NUMBER: 23-014-13

Sunroof Opens But Will Not Close And/Or Cycles Back To Open And/Or Sunroof Glass Scratched

This bulletin involves inspecting sunroof glass clearance and if necessary, modifying the sunroof reinforcement to allow adequate clearance for sunroof glass travel.

Caravan/Town and Country

Fig. 1 Apply Tape

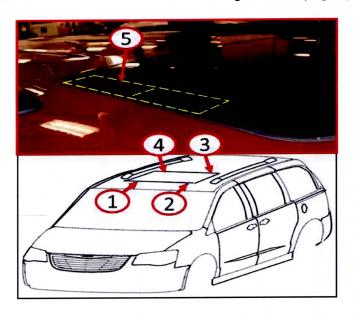
1. Adjust sunroof panel flushness along the front of the glass (1)&(2) to 2mm underflush. Adjust the rear of the sunroof glass panel (3)&(4) to zero/flush (Fig. 1).

2. Apply two pieces of felt/flock tape p/n 05019055AA to each side of the sunroof glass panel. Apply the tape end to end along the side edge of the sunroof glass panel (5) starting at the end of the rear corner radius running forward (Fig. 1).

NOTE: Once the proper glass position has been achieved, tighten the six glass panel attaching screws to 3.5 Nm (31 in. lbs.).

Fig. 2 Inspect

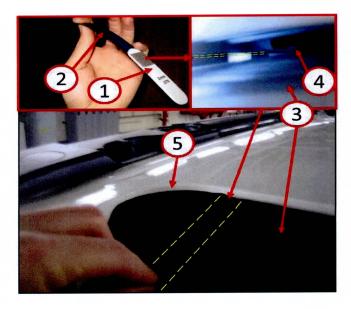
Cycle the sunroof panel to the full open position and use a 2mm feeler gage (1) to check left and right sunroof glass (3) to inner sheet metal reinforcement (4) gap. Use a flashlight to locate the lowest point between the sheet metal reinforcement (4) and sunroof glass (3) (Fig. 2).

Fig. 4 Verify Modification

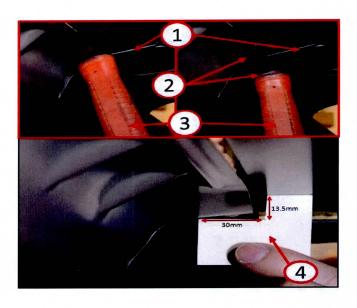
7. Using a backer plate (1) or heavy (3/8"/10mm minimum thickness) cardboard to protect and disburse any pressure applied against the outer roof sheet metal, carefully push the remaining left and right side of the low hanging sunroof reinforcement feature (2) upward using a hammer handle or equivalent blunt tool (3) to provide additional clearance (Fig. 4).

8. Using an index card or folder stock, create a verification gage (4) that will ensure the proper clearance is achieved as a result of modifying the sunroof reinforcement. The gage should measure 13.5mm down from the outer roof panel and 30mm inward from the outer edge of the sunroof reinforcement. Move the verification gage back and forth along this area to ensure proper clearance is achieved (Fig. 4).

NOTE: Repeat the modification procedure for the opposite side of the vehicle or on existing side until desired clearance is achieved.
